RHODE ISLAND DEPARTMENT OF TRANSPORTATION

I-195 Relocation – Contract 16 – Providence River Pedestrian Bridge

NOTICE TO PROSPECTIVE BIDDERS

ADDENDUM NO. 8 Prospective bidders and all concerned are hereby notified of the following changes in the Plans, Specifications, Proposal and Distribution of Quantities for this contract. These changes shall be incorporated in the Plans, Specifications, Proposal and Distribution of Quantities, and shall become an integral part of the Contract Documents.

DESIGNED BY:	SCALE: AS SHOWN	IMPROVEMENTS TO INTERSTATE ROUTE 195 CONTRACT 16 VOLUME 1 BOARDWALK FRAMING PLAN AND SECTION	PROVIDENCE RHODE ISLAND																		
					CHECKED: DATE: SHEET: v1_052 OF: v1_078

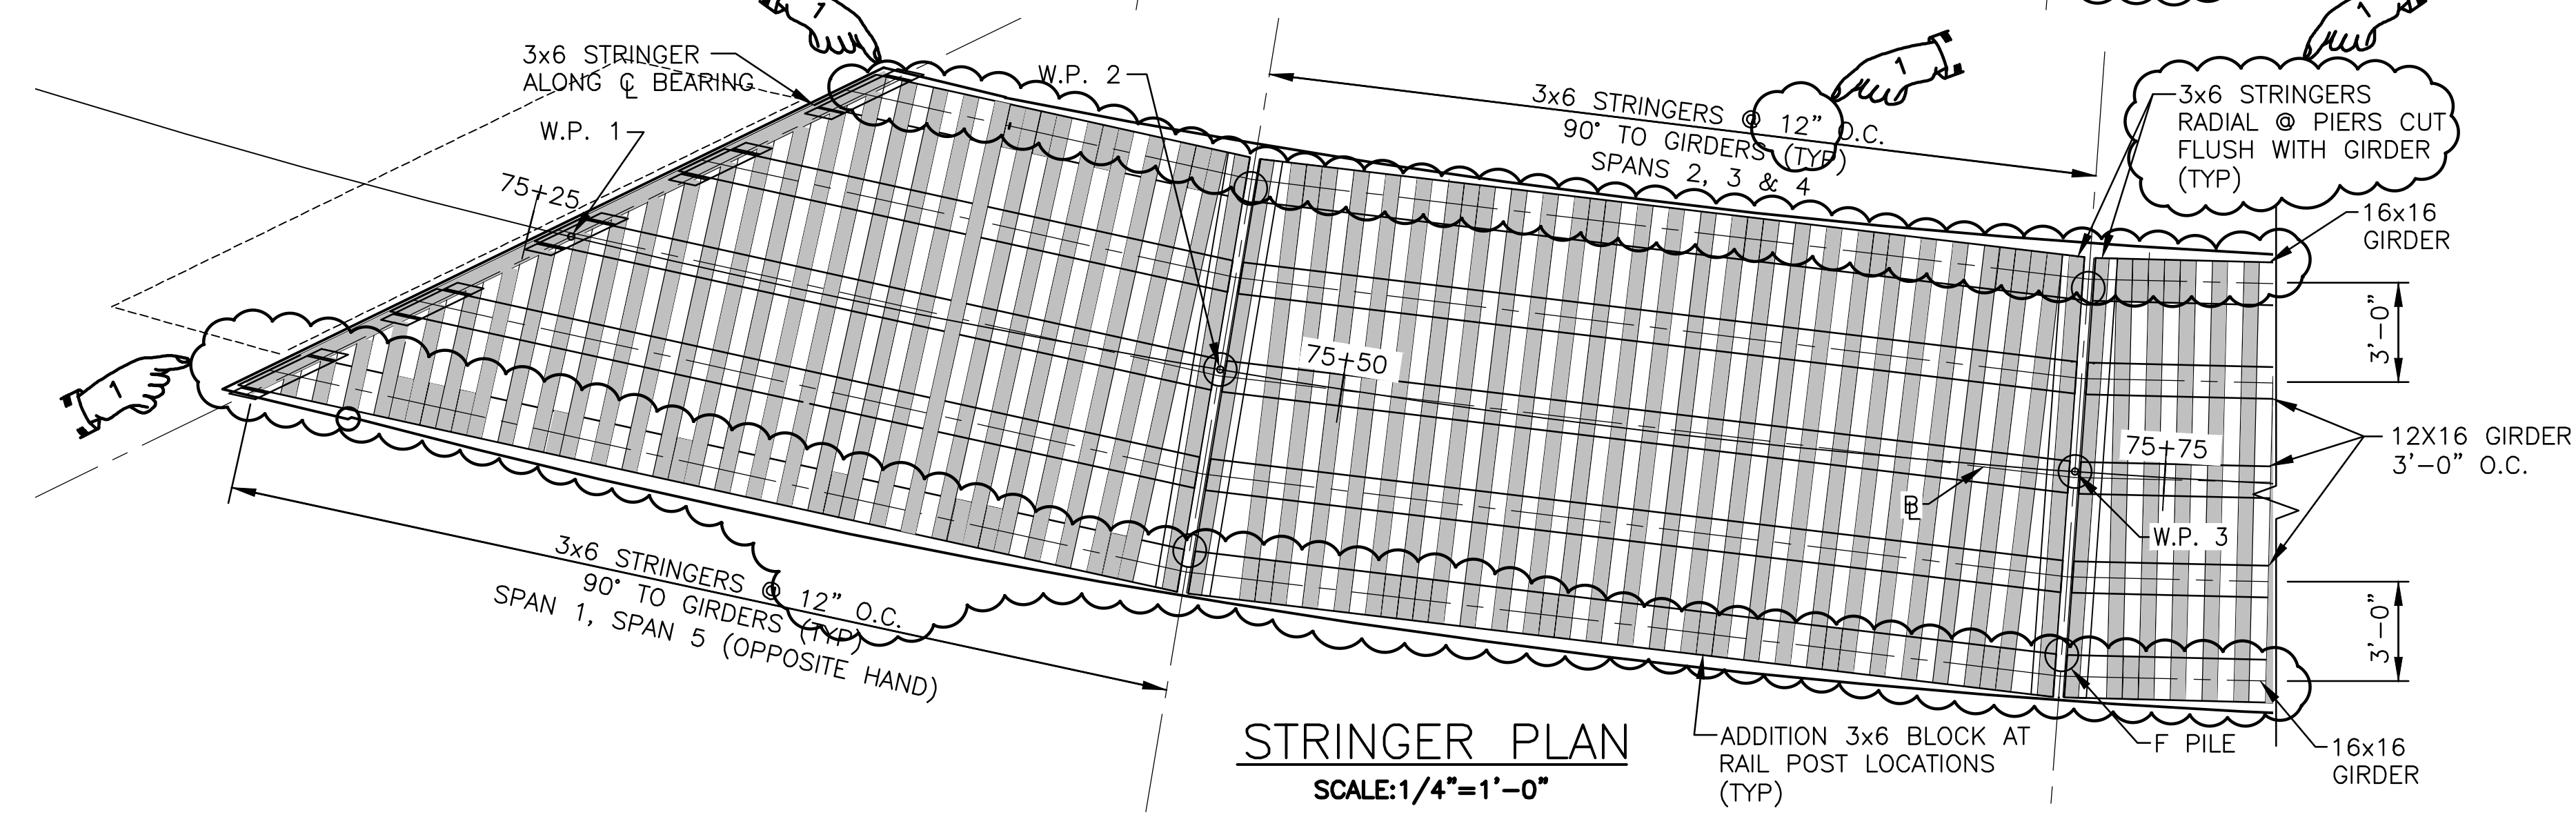
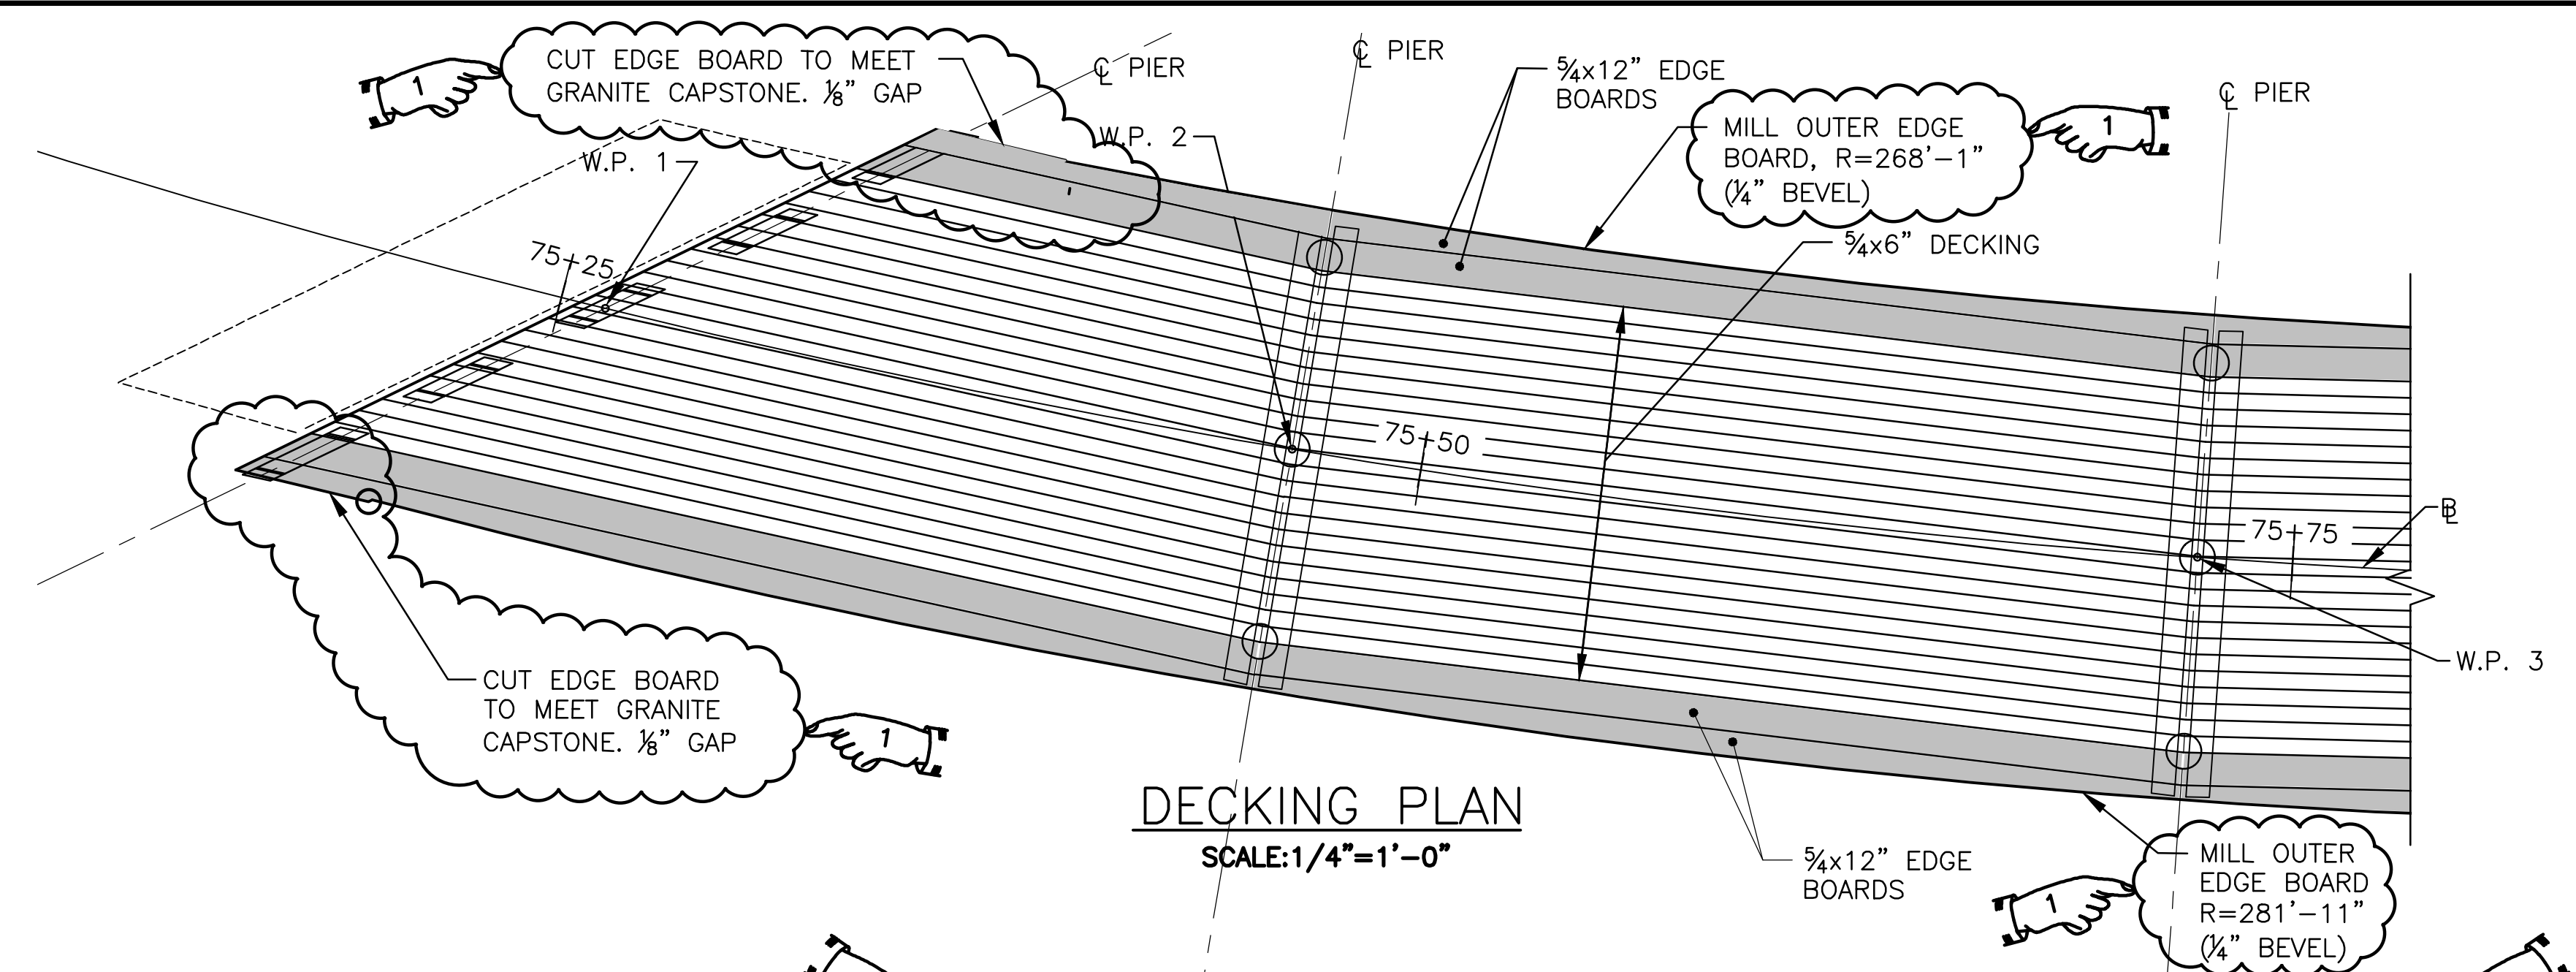
Delete Sheet V1_052(R-1) in its entirety and replace it with sheet V1_052(R-2) attached to this Addendum No. 8. The Cross section detail has been revised.

PIER SECTION
SCALE: 1 1/2"=1'-0"

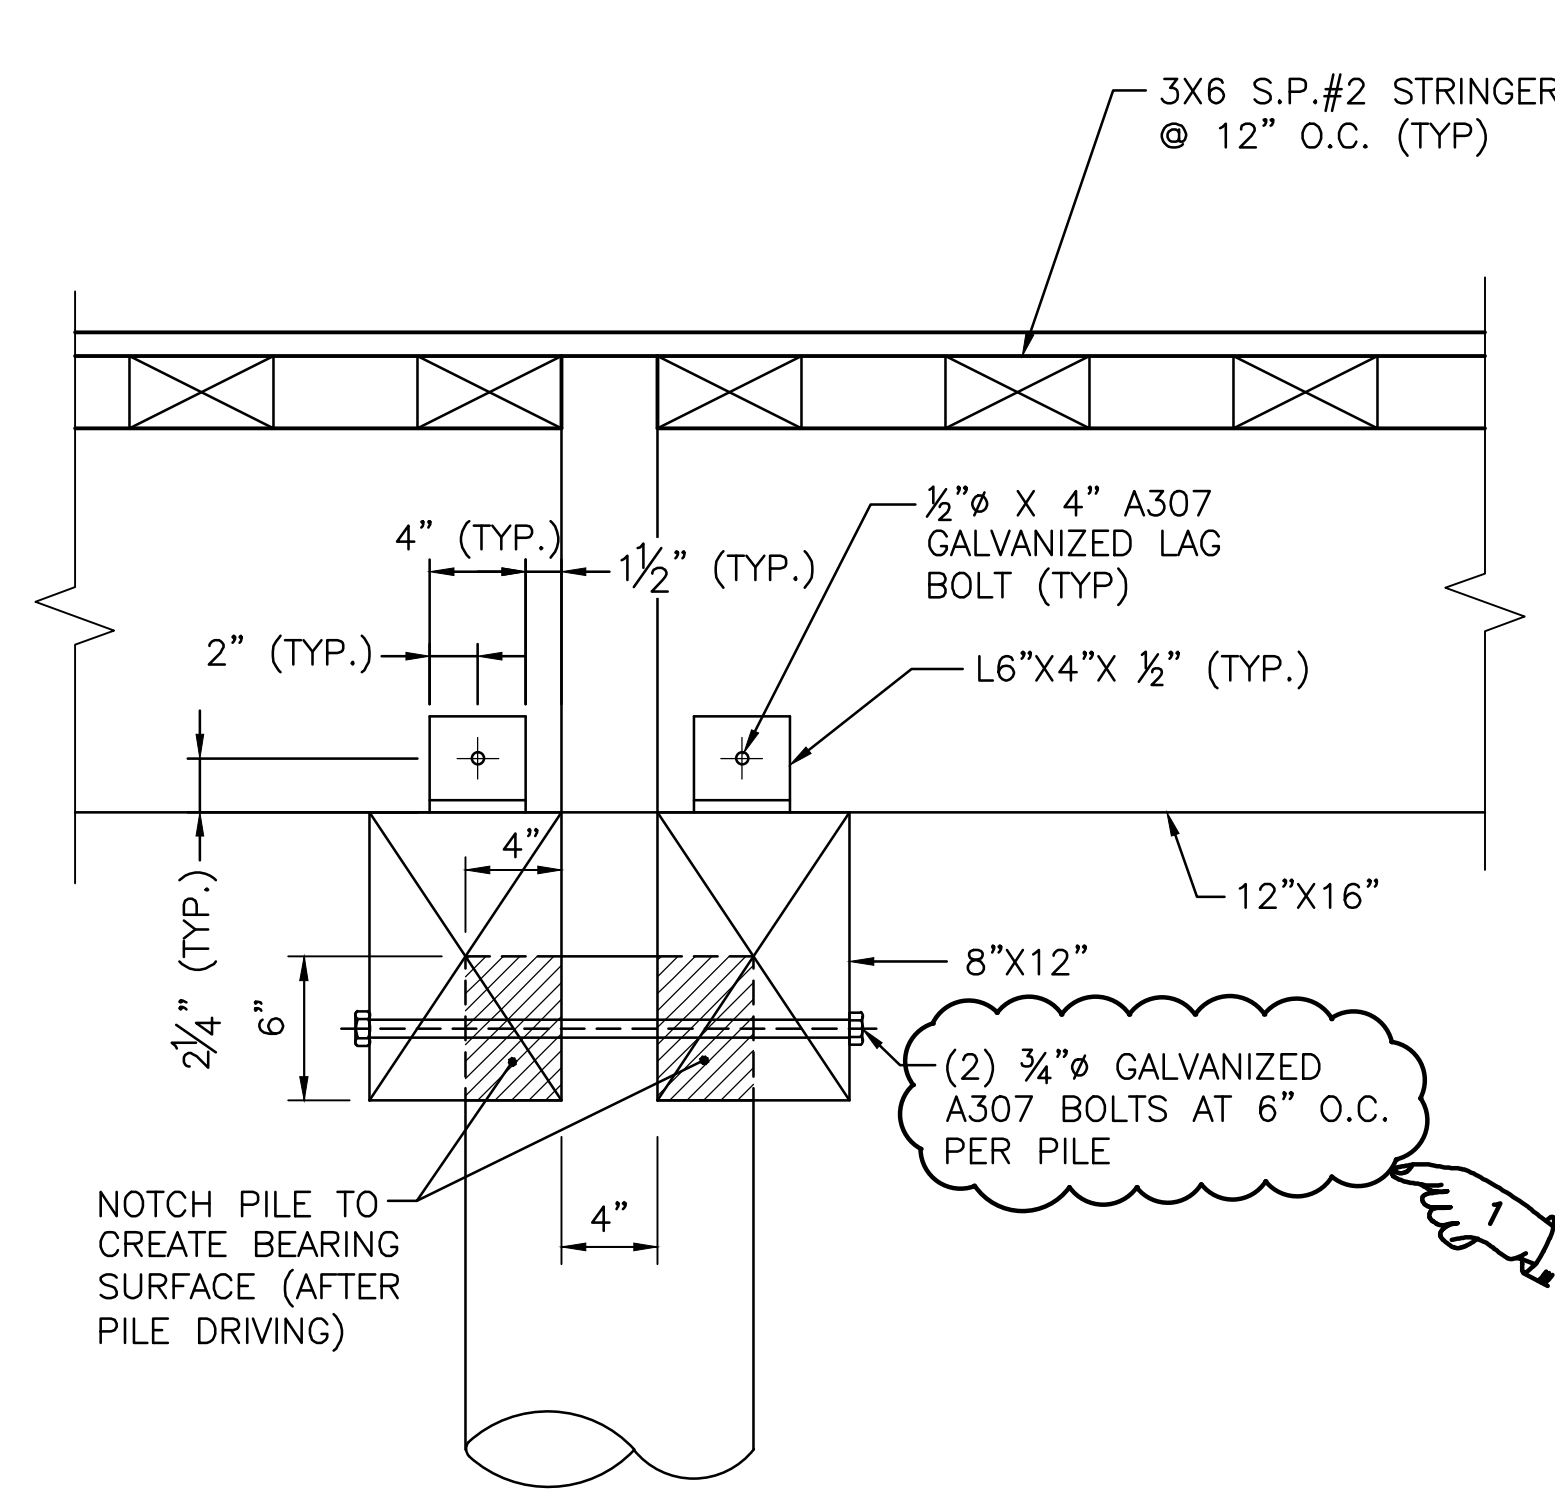
Delete Sheet V1_055(R-1) in its entirety and replace it with sheet V1_055(R-2) attached to this Addendum No. 8. The Pier Section detail has been revised.
